Balboa Park Central Mesa

Precise Plan

Proposed Amendment for
Plaza de Panama, Circulation, and a Parking Structure

April 5, 2012
Sixth Draft

PLAZA DE PANAMA
PLAN

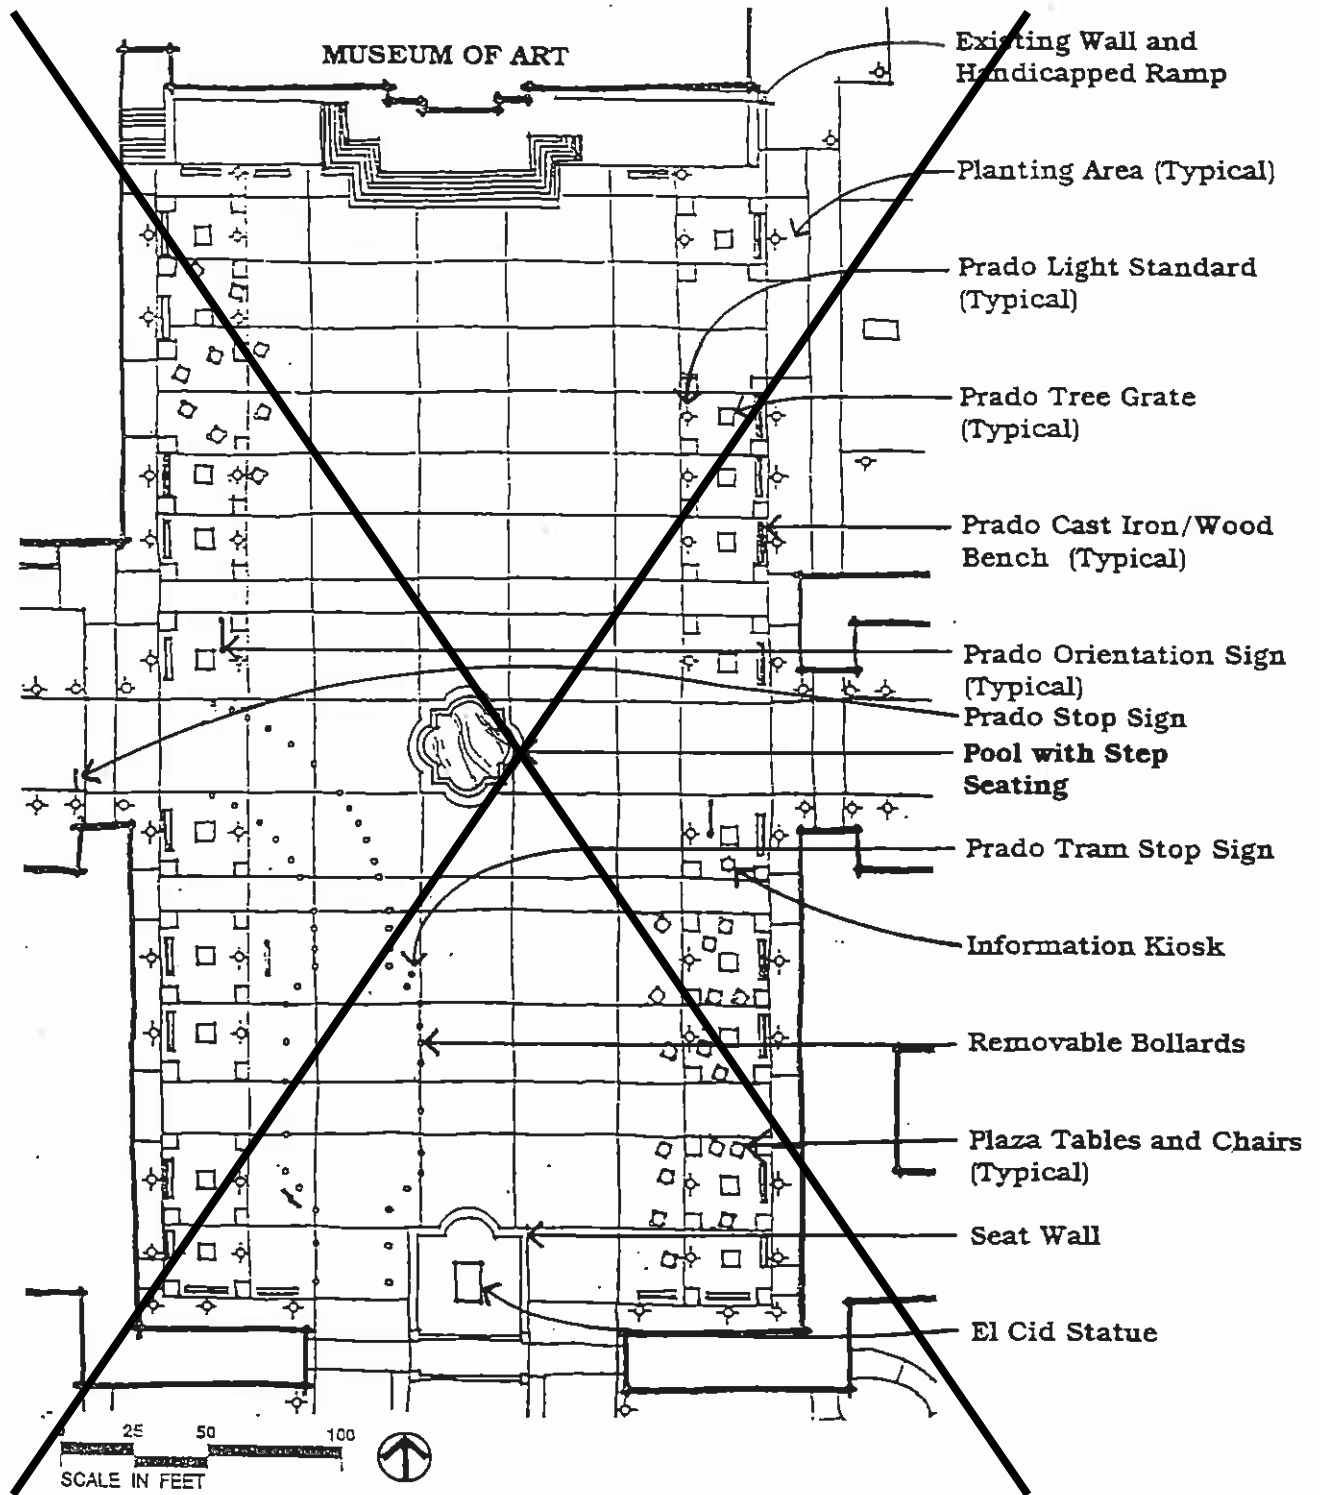
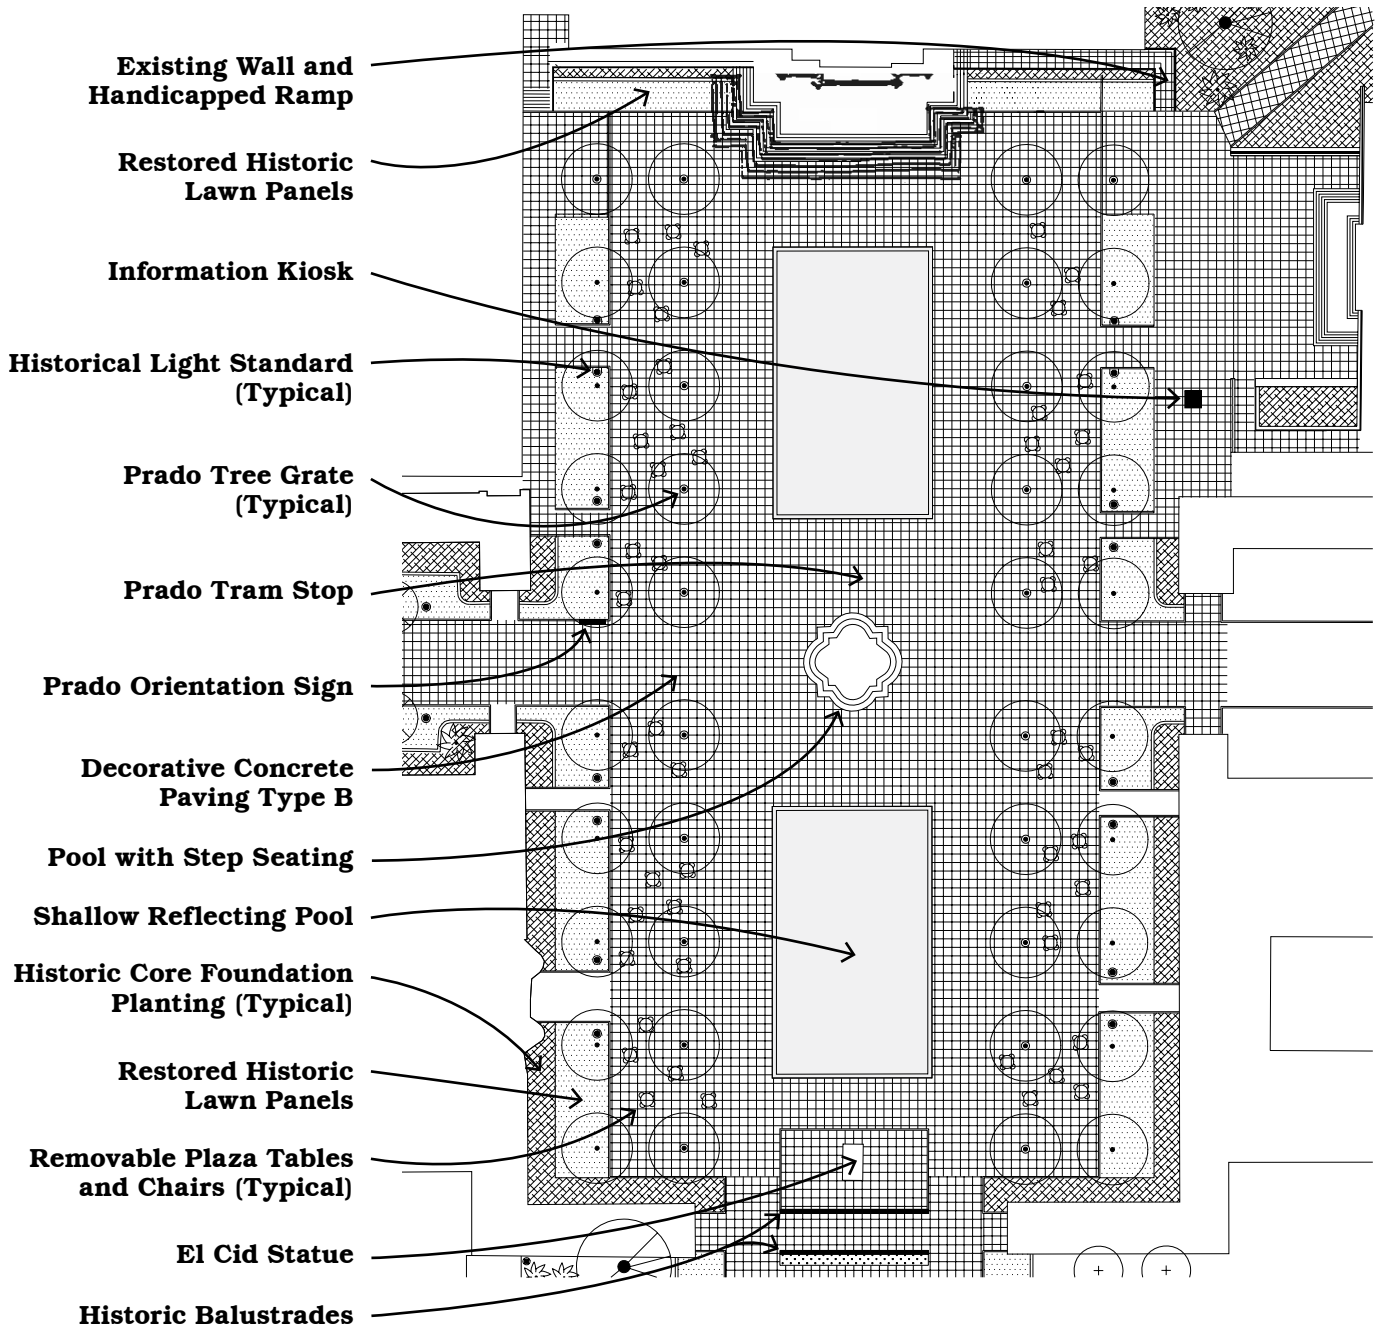
- Place benches along the periphery of the plaza ~~as shown.~~
- Plant bosques of ~~queen palms~~ Plaza de Panama-specific trees at the margins of the plaza.

- Accent the central axial crossing point of the Prado by placing a Spanish Colonial pool in the center of the plaza flanked by shallow reflecting pools to the north and south. ~~Two levels of monumental steps will form the rise to the central pool. These should not exceed 30" in height and be surrounded by a rim that is a minimum of 16" wide to provide seating. Concealed down lights built into the pool steps should be included. Mosaic tiles inside the pool should repeat historic motifs such as the sunburst design found on the tile dome of the California Building. Decorative brass fixtures should also be included inside the pool to support a portable stage deck for special events.~~

- Provide aesthetically pleasing night lighting in the plaza. Features in the Plaza de Panama to highlight will be the trees bosques of palms, the central Spanish Colonial pool, the two reflecting pools, El Cid, and the surrounding arcades and architecture.

- Create two shallow reflecting pools in the plaza, one north and one south of the central Spanish Colonial fountain.
- The pools should have the ability to be deactivated if necessary.
- The depth of the pools should not exceed 1/2” such that when deactivated the surface can be used as part of the plaza space.
- Consider intermittent water jet features to activate the shallow reflecting pools as a play area.
- ~~Locate a seat wall around the statue of El Cid, enclosing seasonal flower beds.~~
- Provide unobtrusive and secure electrical service to support sound and lighting equipment in several areas of the plaza. Provision should also be made for power to be provided to a stage that could be set up over the central fountain.

8. The Mall

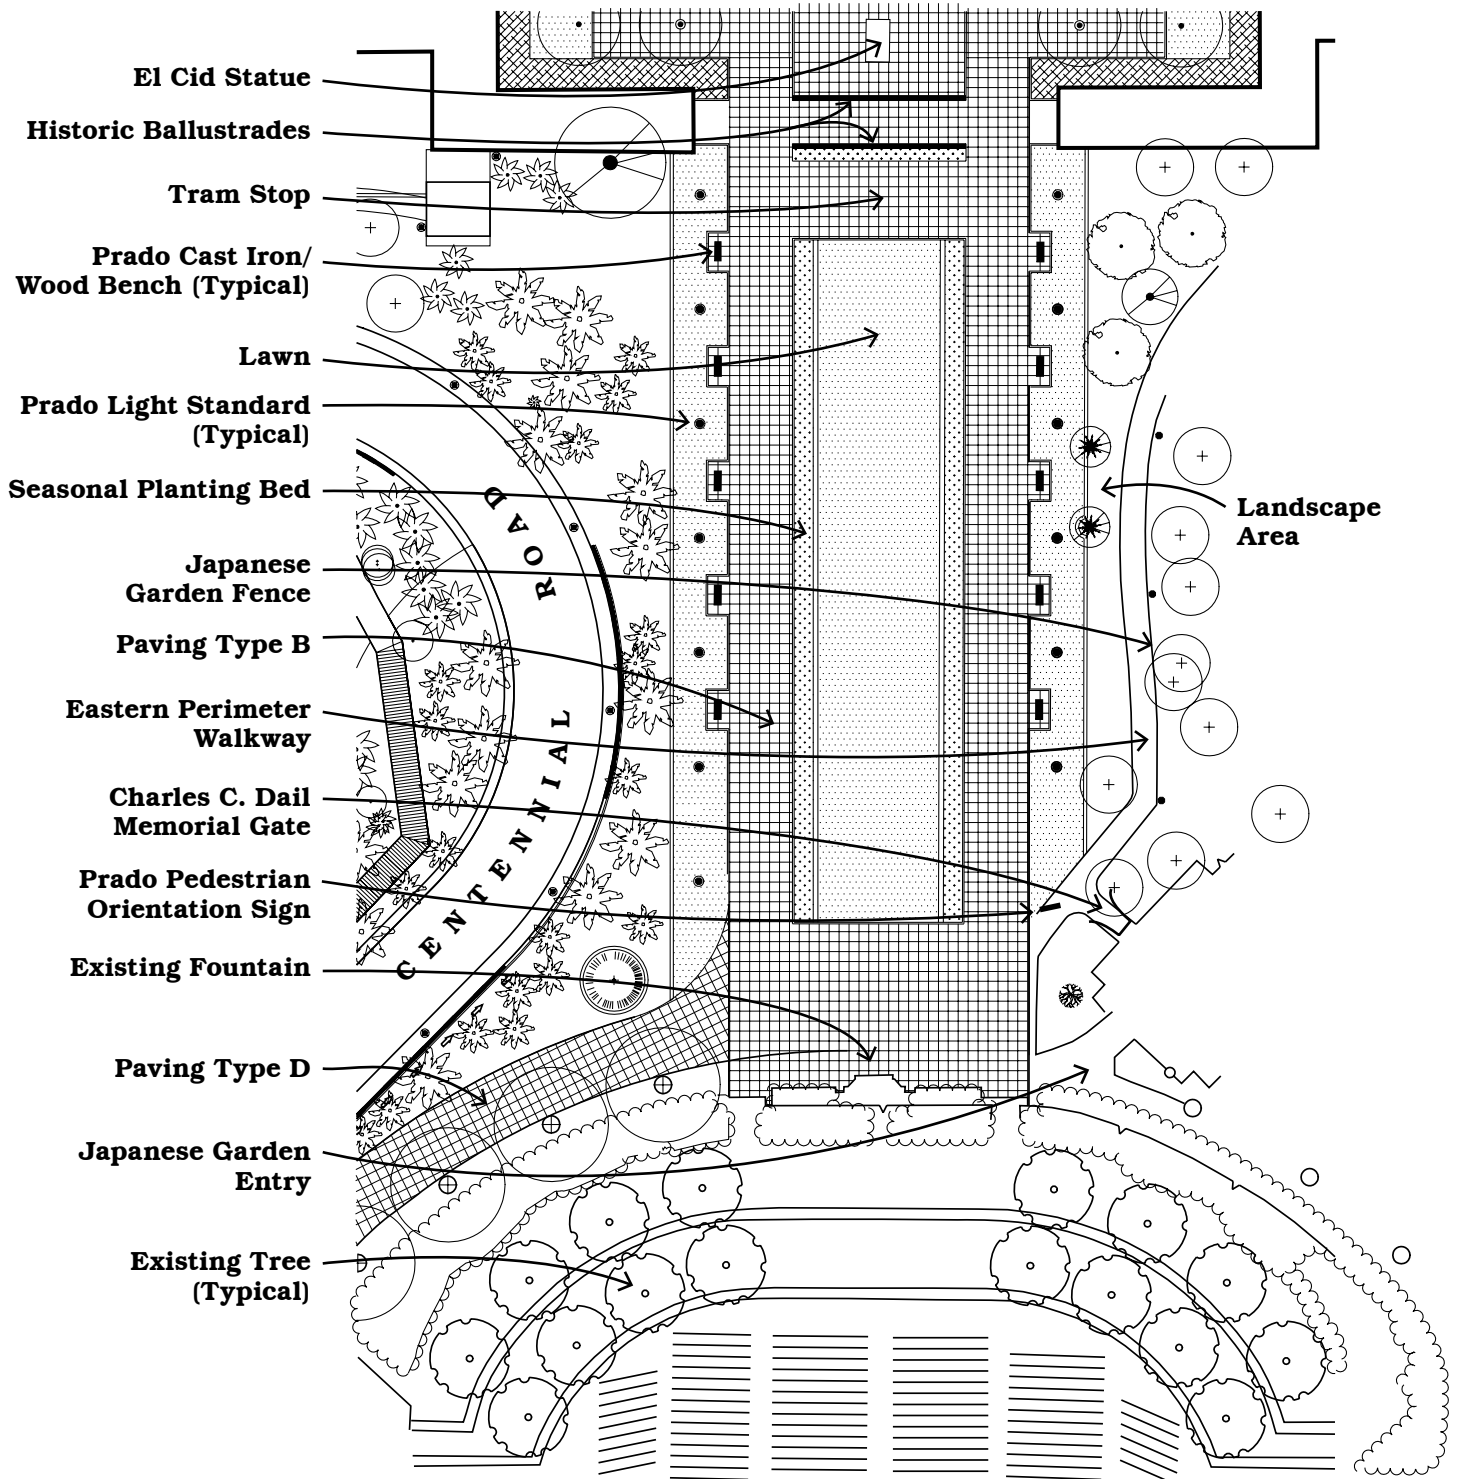
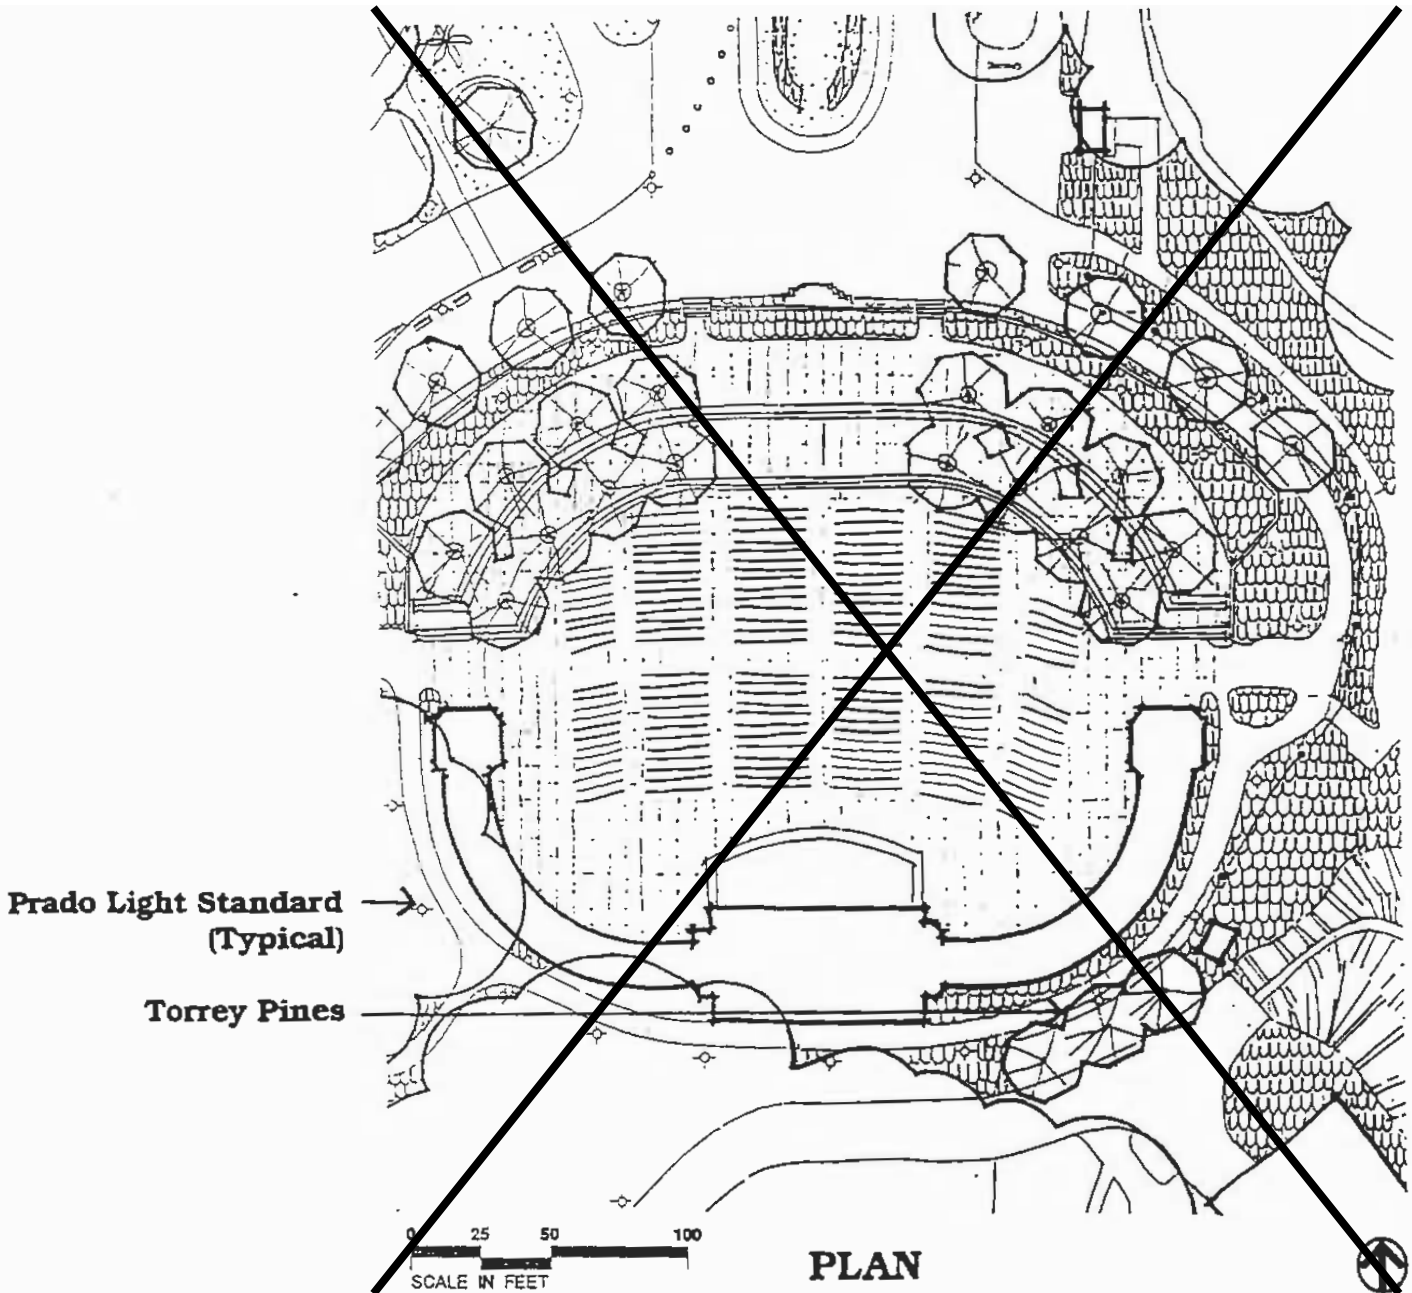
- ~~Retain the existing configuration of the central landscaped area containing lawn and seasonal planting beds.~~
- ~~Border the planting area with a six foot wide type C concrete sidewalk separated from adjacent paving by a six inch curb.~~

- Restore the central landscaped area to its original 1915 proportions.
- Relocate the existing backflow preventer device located in the central landscaped area to a location hidden from public view.

- ~~Separate automobile circulation from pedestrian areas south of the central planting area with bollards that match the Prado light standard bases.~~

- Relocate existing Queen Palms to other locations in the Park to provide an unobstructed view of the Organ Pavilion from the Plaza de Panama and reintroduce a row of Mall-specific deciduous trees along the east and west edges of the space to emphasize the Mall as an important physical and visual axis between the Organ Pavilion and the Plaza de Panama.
